RS-01-052

Subject: Additional Electrical Information Supporting the License Amendment Request to Permit Up-rated Power Operation at Dresden Nuclear Power Station and Quad Cities Nuclear Power Station

Attachment A: Additional Electrical Information Supporting the License Amendment  
Request to Permit Up-rated Power Operation at Dresden Nuclear Power  
Station

Attachment B: Additional Electrical Information Supporting the License Amendment  
Request to Permit Up-rated Power Operation at Quad Cities Nuclear  
Power Station

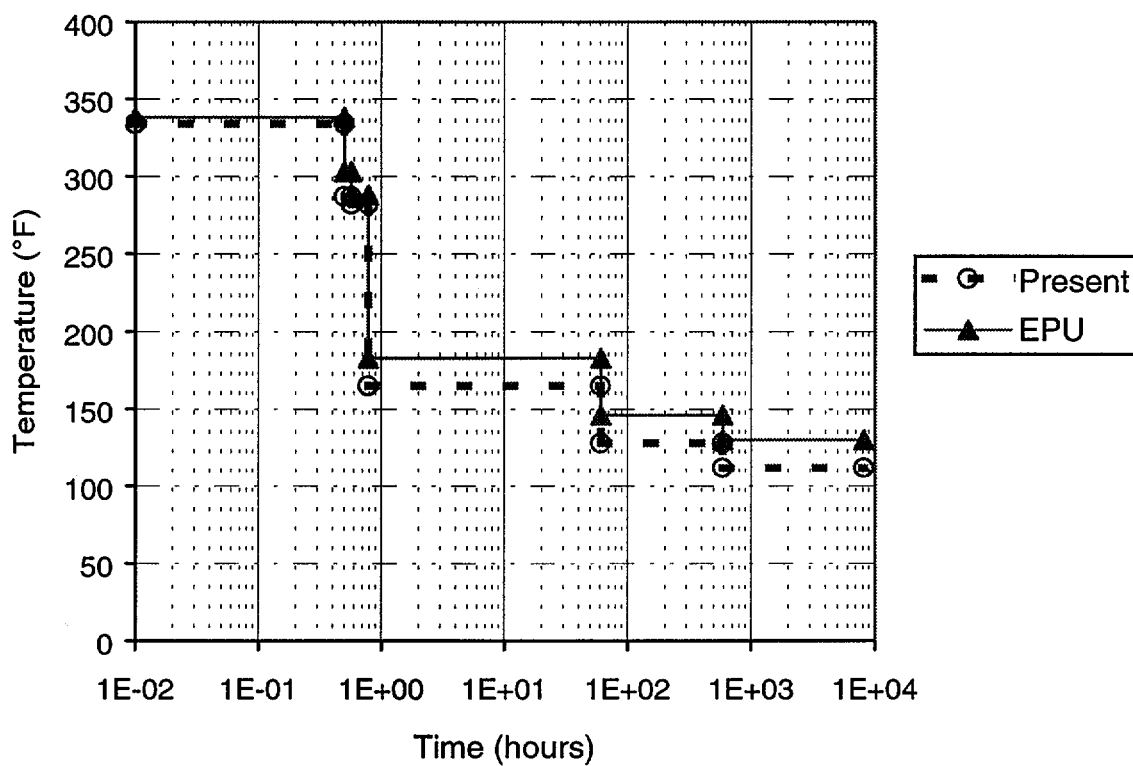
7. *In Section 10.3.1.1, the licensee stated that the current accident conditions for temperature and pressure are modified for the EPU conditions. Provide a discussion regarding the effect of modified temperature and pressure for the EPU conditions on environmental qualification (EQ) of electrical equipment inside containment.*

1. The present drywell peak pressure for qualification of 63 psia is bounding for the EPU condition.
2. The present and EPU drywell temperature profiles used for EQ are shown in the table and figure on the following page.

For all equipment inside the containment within the EQ program, evaluations were performed to demonstrate that the existing environmental documentation was adequate to meet the revised temperature and pressure values due to EPU. Evaluations were done for each equipment type using the following approach.

1. The qualification test temperature conditions for the required operability period during the first 24 hours following a LOCA were shown to envelop the corresponding EPU temperature profile.
2. The qualification test temperature conditions for the required operability period beyond 24 hours to 1 year following a LOCA were shown to meet the revised EPU temperature profile using Arrhenius methodology.
3. Maximum test pressure was shown to envelop the revised peak pressure for EPU.

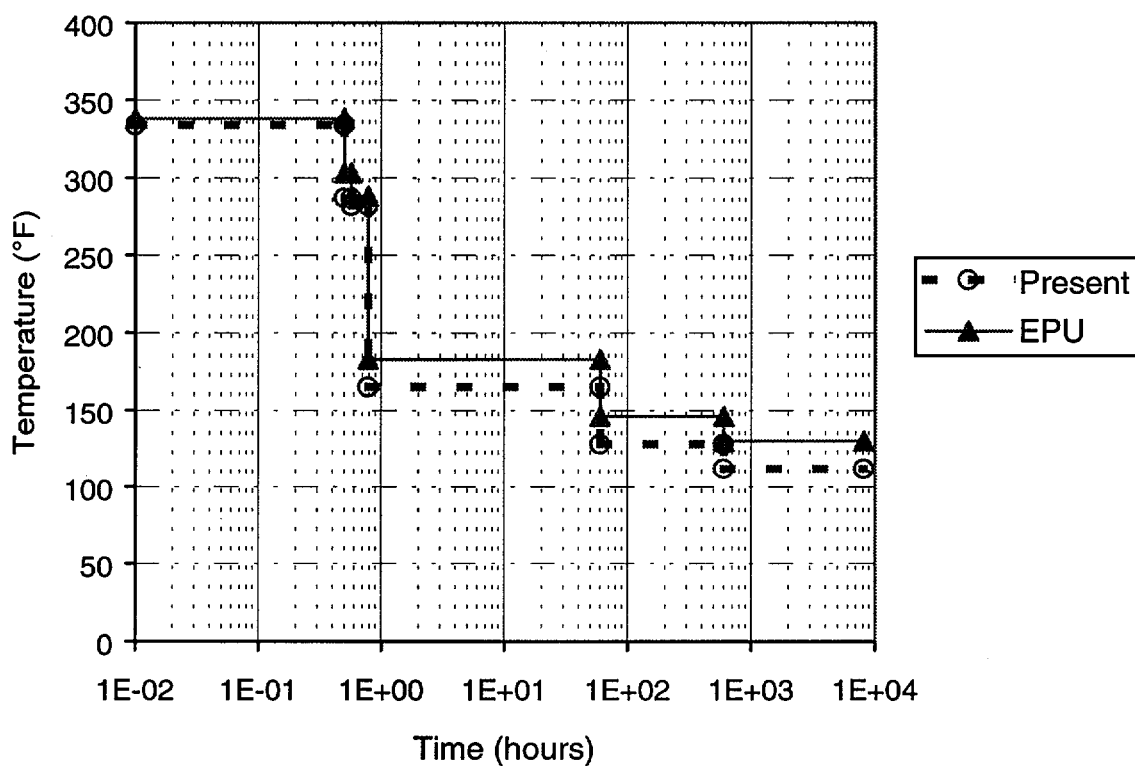
7. *In Section 10.3.1.1, the licensee stated that the current accident conditions for temperature and pressure are modified for the EPU conditions. Provide a discussion regarding the effect of modified temperature and pressure for the EPU conditions on environmental qualification (EQ) of electrical equipment inside containment.*

1. The present drywell peak pressure for qualification of 63 psia is bounding for the EPU condition.
2. The present and EPU drywell temperature profiles used for EQ are shown in the table and figure below.

For all equipment inside the containment within the EQ program, evaluations were performed to demonstrate that the existing environmental documentation was adequate to meet the revised temperature and pressure values due to EPU. Evaluations were done for each equipment type using the following approach.

1. The qualification test temperature conditions for the required operability period during the first 24 hours following a LOCA were shown to envelop the corresponding EPU temperature profile.
2. The qualification test temperature conditions for the required operability period beyond 24 hours to 1 year following a LOCA were shown to meet the revised EPU temperature profile using Arrhenius methodology.

3. Maximum test pressure was shown to envelop the revised peak pressure for EPU.
